ADDENDUM NO. 3

FY25 Stormwater Improvements

City of Seminole

A. Sheet C8, Plan & Profile (Baywood Park Drive)

4. **RESPONSE TO SUBMITTED QUESTIONS: NO CHANGE**

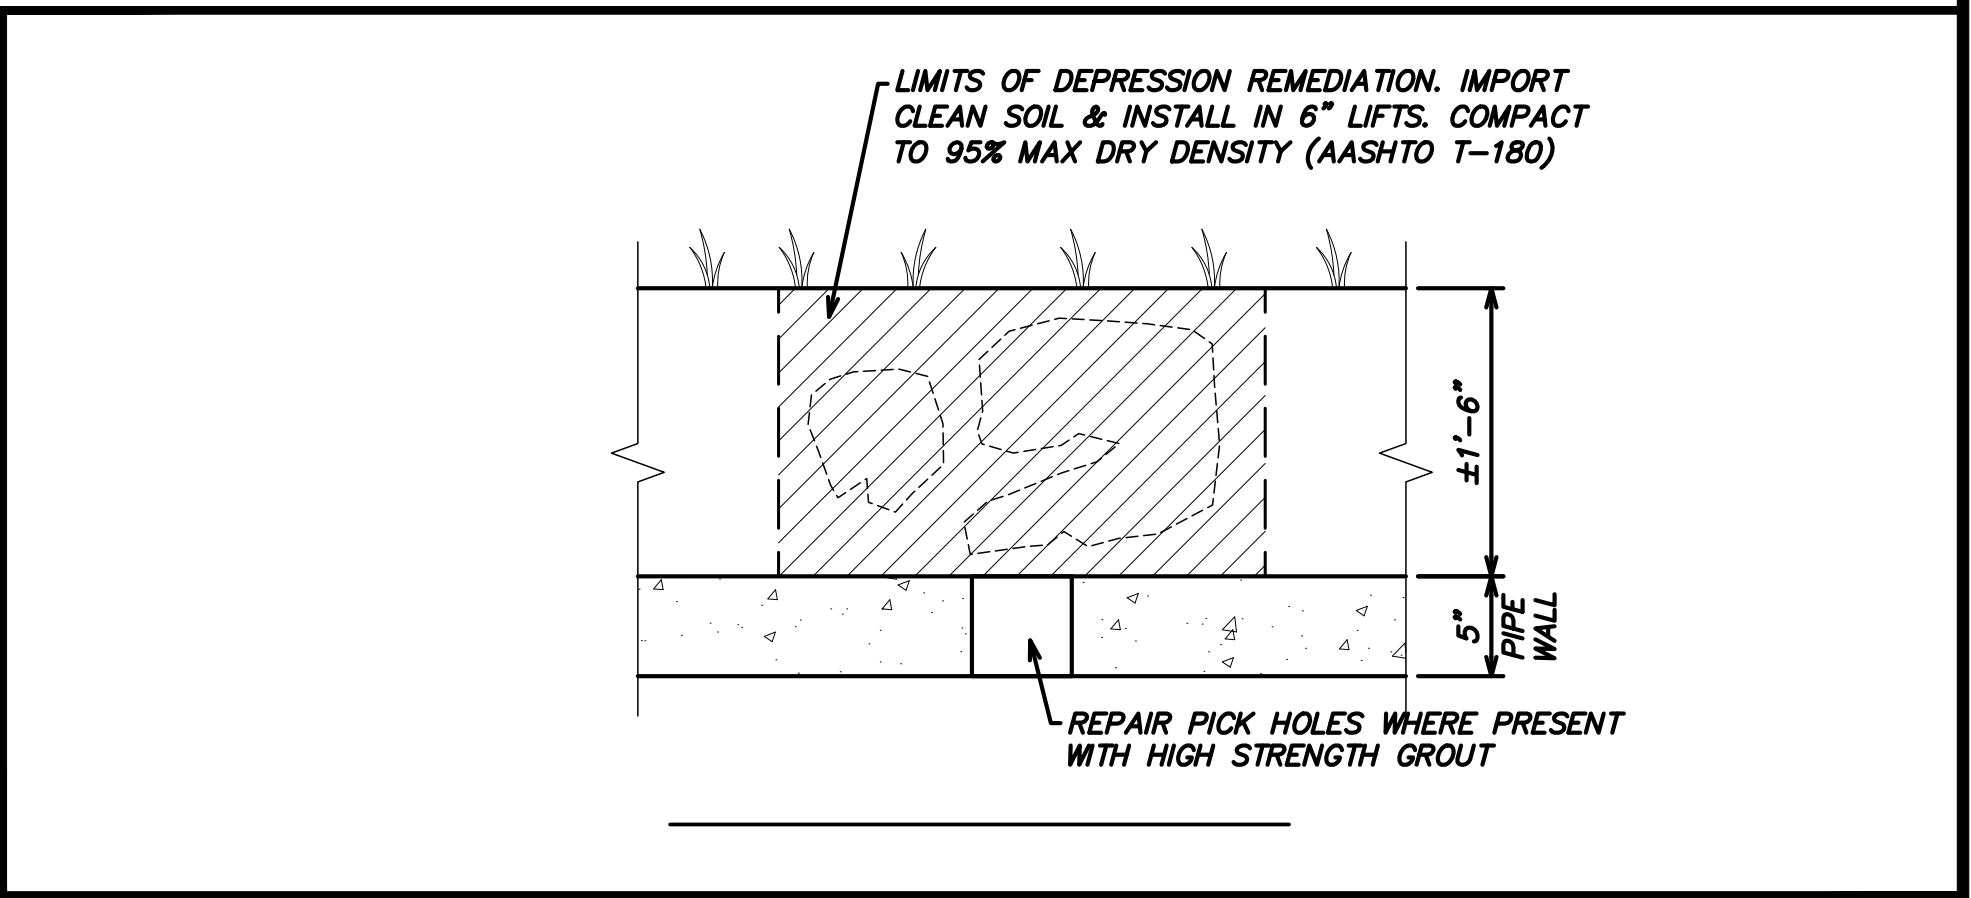
The location of the manhole structure has changed. The alignment of the sanitary sewer has been updated. A callout has been added regarding the buried electric line that crosses the street within the project area.
